**RE: Fountains at Endhaven, Charlotte, NC
2012 NCPD Section 405.3.1 Clearance Requirements Between Lavatories**

This letter is in response to your request for formal interpretation dated March 12, 2020 that was received in NCDI by email on March 16, 2020. Your request for formal interpretation states:

Conclusions:

All lavatory fixtures are required by Section 405.3.1 to be spaced a minimum of 30 inches center-to-center of the lavatory bowl.

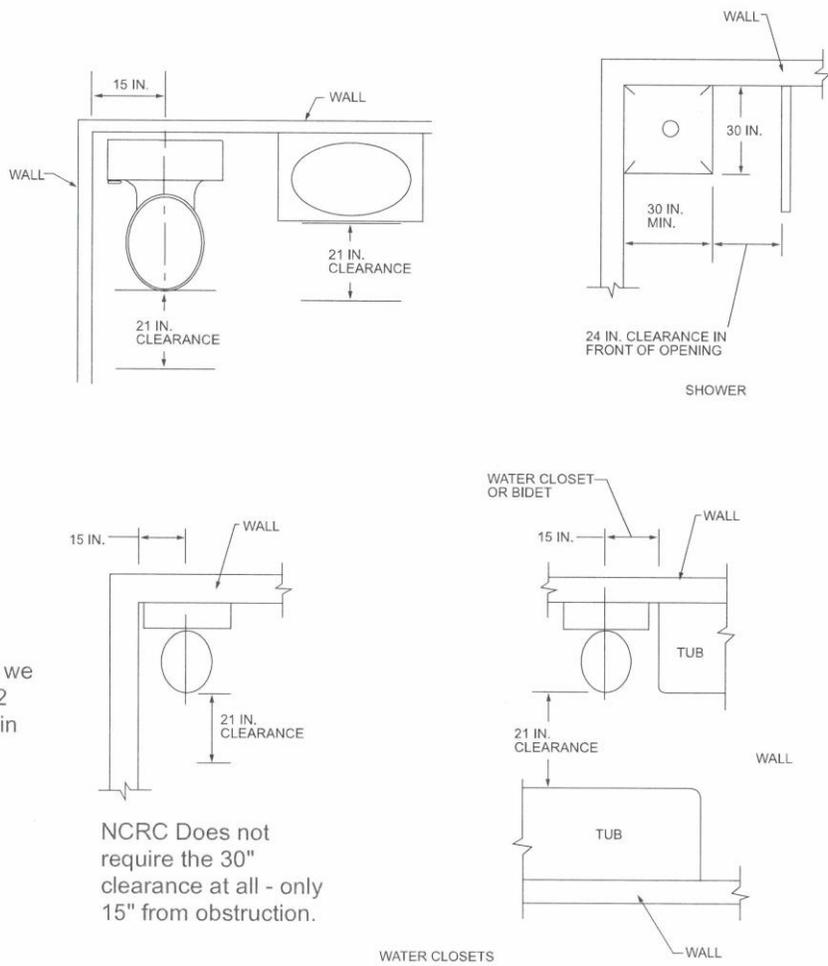
Above: 27" spacing with two grown men showing ample space for use.
Below: Required ANSI clear floor space shown at both sinks.

FIGURE R307.1
MINIMUM FIXTURE CLEARANCES

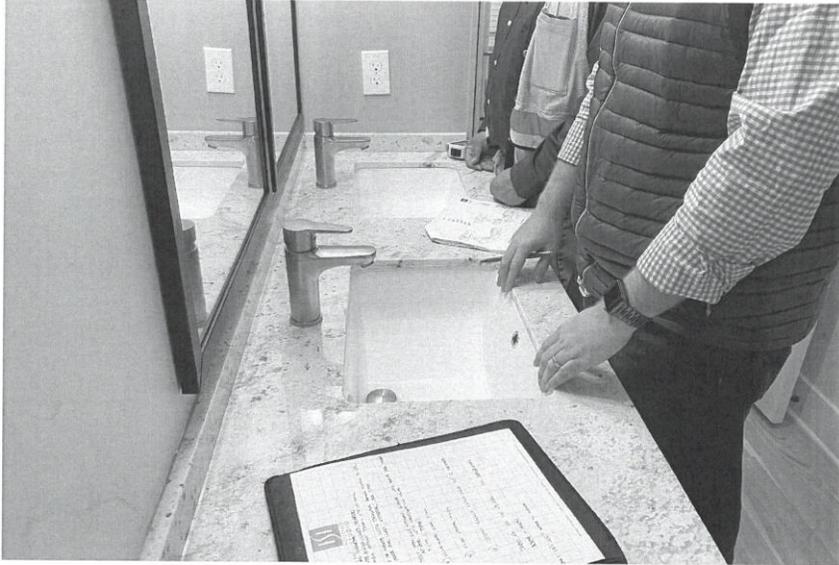
NCRC Does not require the 30" clearance at all - only 15" from obstruction.
